# UNITED STATES PATENT AND TRADEMARK OFFICE

APPLICATION NO.	FILING DATE	FIRST NAMED INVENTOR	ATTORNEY DOCKET NO.	CONFIRMATION NO.
09/737,770	12/18/2000	In-Duk Song	8733.339.00 8950 EXAMINER	
30827	7590 01/26/2005			
MCKENNA LONG & ALDRIDGE LLP 1900 K STREET, NW			RUDE, TIMOTHY L	
	ON, DC 20006		ART UNIT	PAPER NUMBER
	•		2883

## **DETAILED ACTION**

FIG.2E

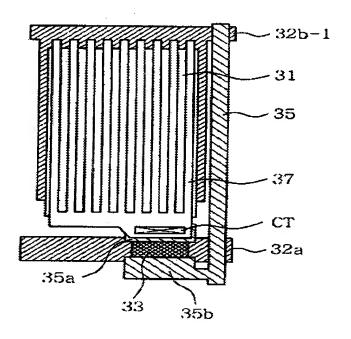
Jeon teaches 1) in Figures 2A-2E, an in-plane switching LCD device comprising: a gate line, 32a, on a first substrate; a data line, 35, on the first substrate, the data line being perpendicular (as illustrated) to the gate line; a common line, 32b-1, on the first substrate, the common line being parallel (as illustrated) with the gate line and being

formed of a metal (Applicant's first material, Cr for both gate line and common line; col. 2, lines 49-58, especially lines 55-58) (Applicant's wherein the common electrode is formed on the substrate like the gate line); a pixel electrode, 37, (ITO; col. 3, lines 18-22) and the common electrode, 31, (ITO; col. 2, lines 64-67) being formed of a transparent conductive material (ITO, Applicant's second material different from the first material); and a liquid crystal layer between the first and second substrates (inherent to comprising a LCD device) made by a method that simplifies the process by reducing the mask number.

As to claim 17, Jeon discloses in Figures 2A-2E, in-plane switching Liquid Crystal Display (LCD) device, comprising: a first substrate and a second substrate a gate line, 32a, on the first substrate; a metal common line, 32b, (Cr for both gate line and common line; col. 2, lines 49-58) on the first substrate, the common line parallel (as illustrated) to the gate line, a data line, 35, on the first substrate, the data line being

perpendicular (as illustrated) to the gate line; a common electrode, 31, on the first substrate; a thin film transistor having a gate electrode, a source electrode, 35a, and a drain electrode, 35b, formed on the first substrate; liquid crystal interposed between the first and second substrates (inherent to comprising a LCD device); a pixel electrode, 37, contacting the source electrode (Applicant's drain electrode) of the thin film transistor; and wherein, the pixel and common electrodes are formed of a transparent conductive material (ITO; col. 3, lines 18-22, and col. 2, lines 64-67).

As to claim 18, Jeon, as combined above, discloses the LCD device of claim 17, wherein a portion of the common line overlies a portion of the common electrode (Figures 2A-2E, especially Figure 2C, and col. 2, lines 49-67, especially lines 64-67).

FIG. 3

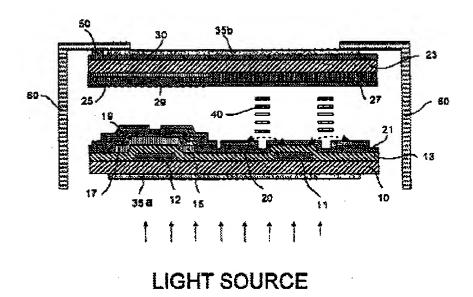
Son teaches in Figure 3, an LCD device, further comprising a light-shielding layer, 25, (Applicant's black matrix) on the second substrate, 23, (para 0029).

Son is evidence that ordinary workers in the art of liquid crystals would find the reason, suggestion, or motivation to use a black matrix on the second substrate to prevent light from leaking around the TFT (first two lines of para 0029).
